**Before the Hearings Panel
At Wellington City Council**

In the matter of Hearing submissions and further submissions on the
Proposed Wellington City District Plan

**Stream 2 Reporting Officer Right of Reply of Josh Patterson on behalf of
Wellington City Council**

Date: 29 May 2023

Figure 1 - Before Rezoning

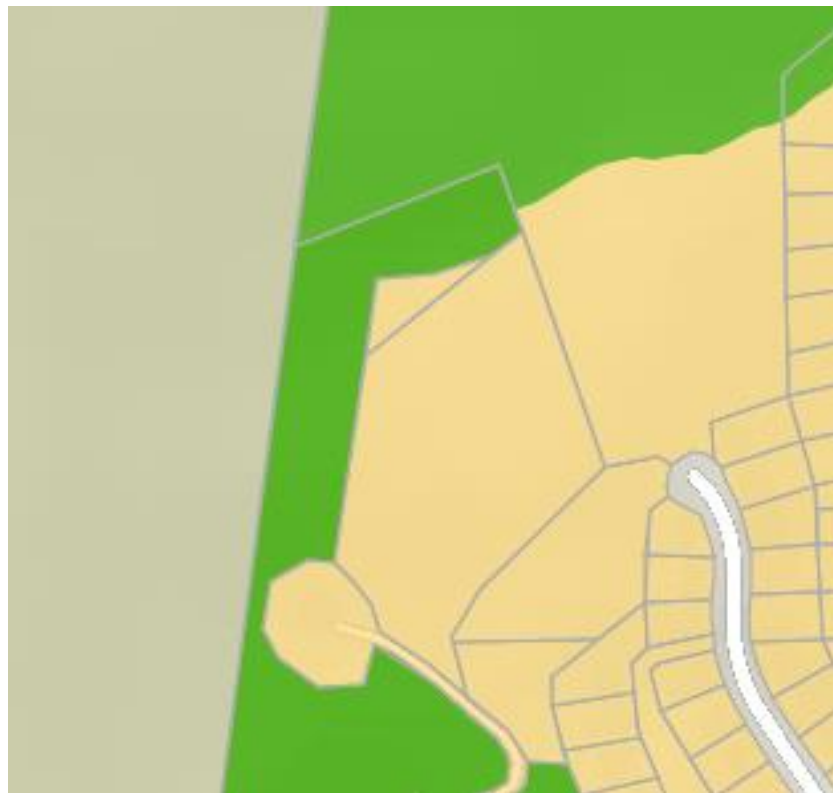
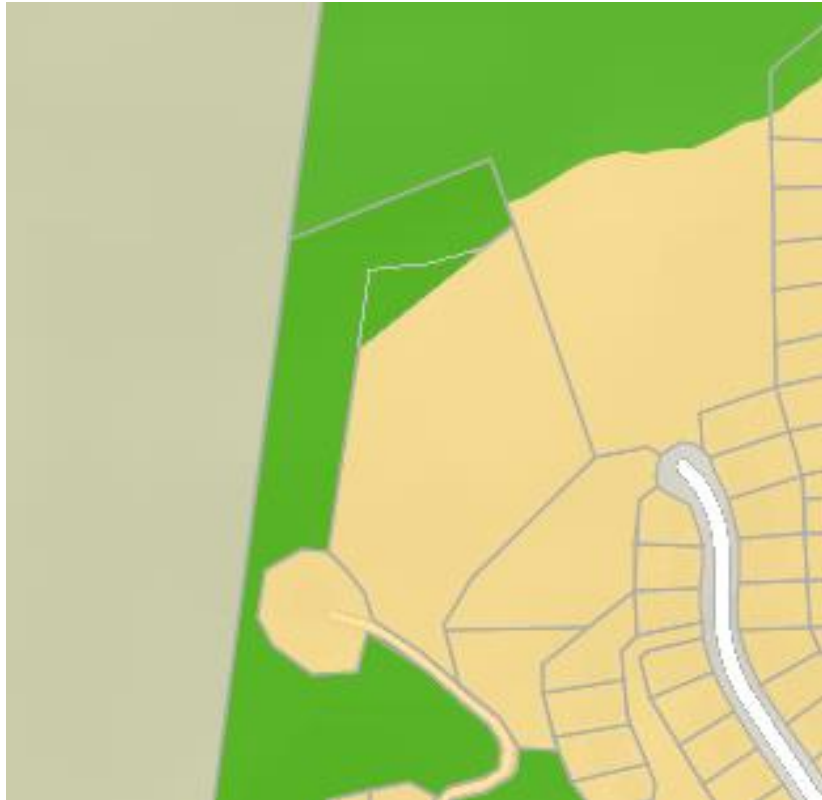
What is Council Officers' response to Mr Halliday's presentation as regards the Council at 35 Bickerton Street, and whether it should more appropriately be OSZ?

- 113 I agree with Mr Halliday that the land identified as Lot 5 DP 524106 should be rezoned to Natural Open Space Zone. The land was vested as scenic Reserve in 2021 and I consider that the appropriate zoning is Natural Open Space to reflect this, as shown below.

Figure 3 - Before Rezoning

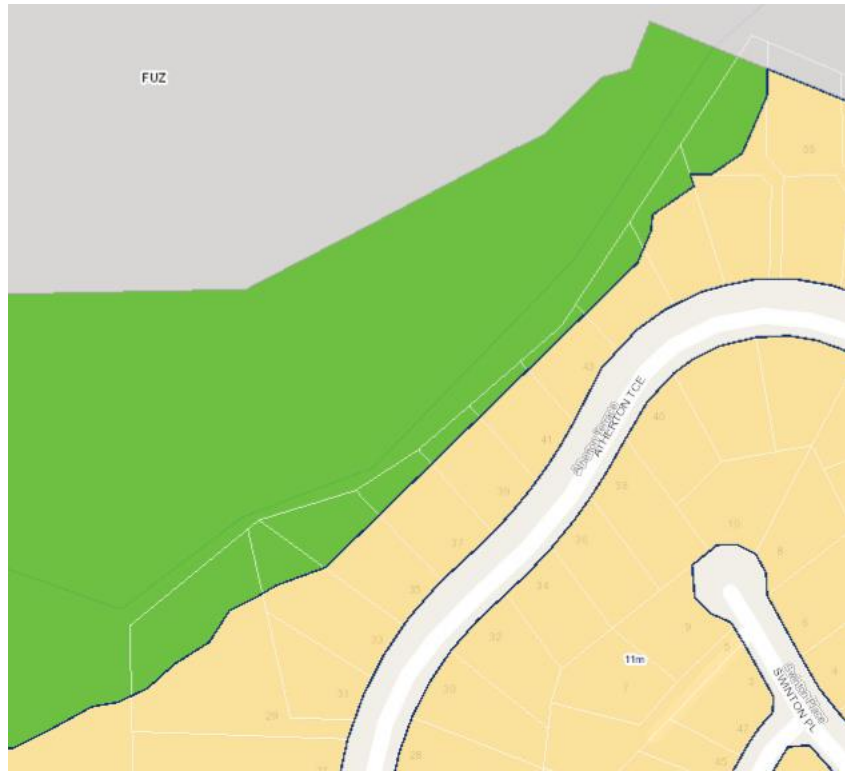
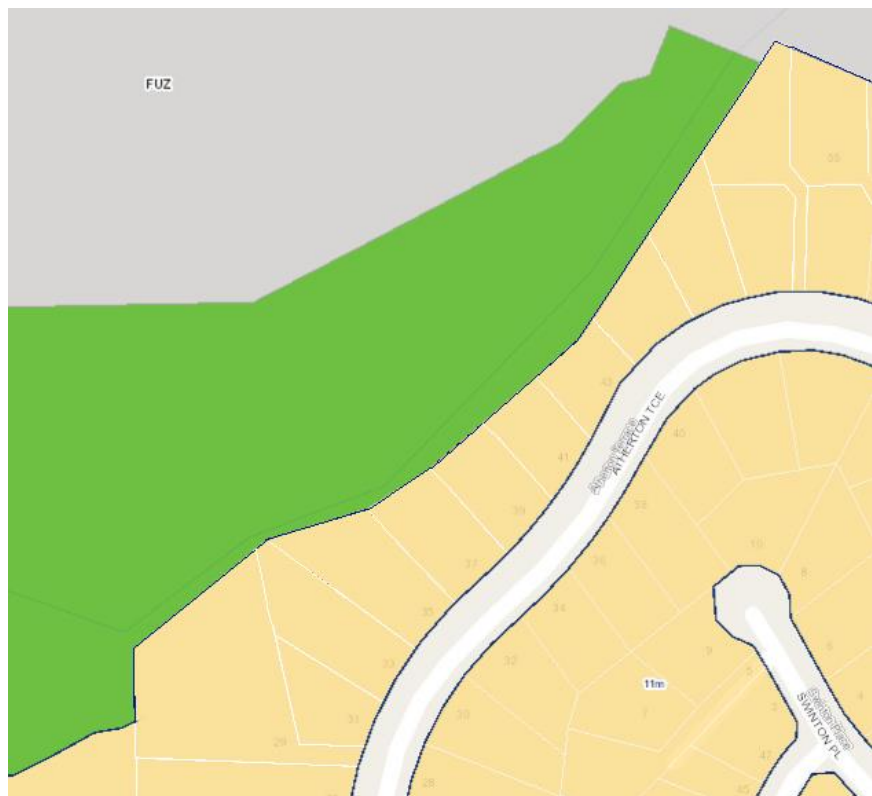
Panel request: Have Council Officers reconsidered their view in relation to Mr Halliday's proposed extension of the MRZ zoning in Atherton Terrace to match property boundaries?

114 I have reconsidered my view in relation to the properties in Atherton Terrace. I agree with Mr Halliday that the zoning should be amended to follow the property boundaries, as shown below.

Figure 5 - Before Rezoning.

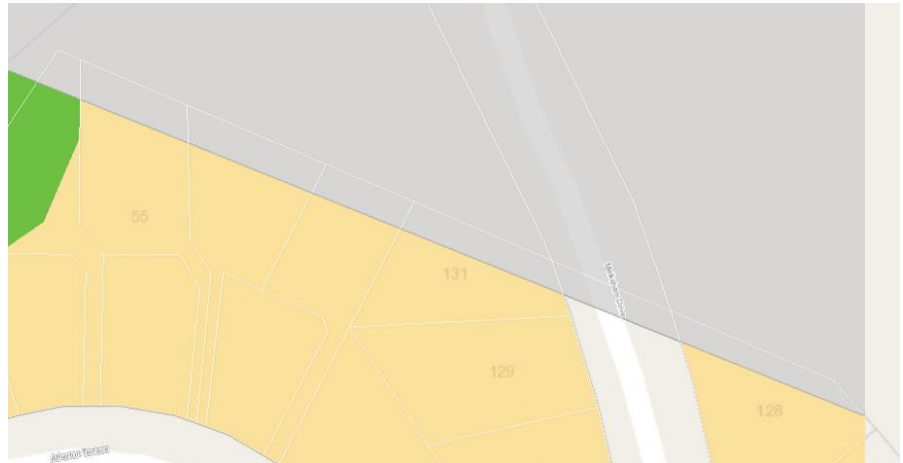
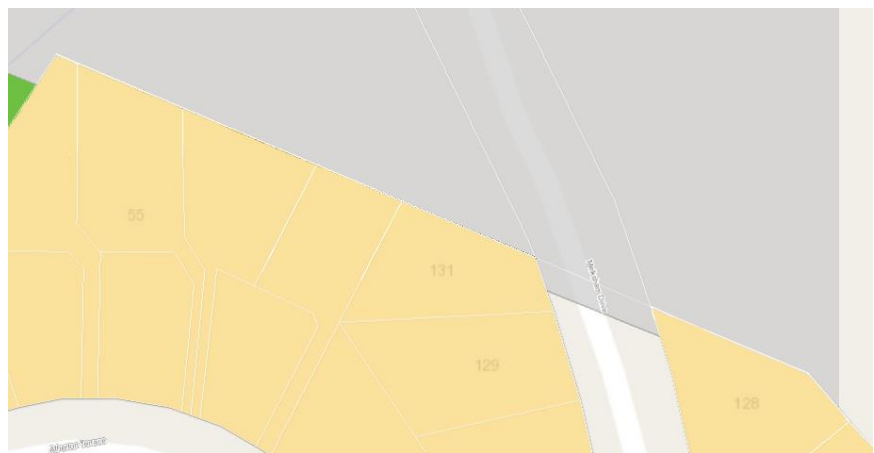
115 Whilst amending the zoning to follow the property boundaries along Atherton Terrace, I noticed that there are several properties, also on Atherton Terrace and on Melksham Drive, which have a similar issue in relation to the Future Urban Zone protruding into the back boundaries. I recommend that these properties are also rezoned as shown below:
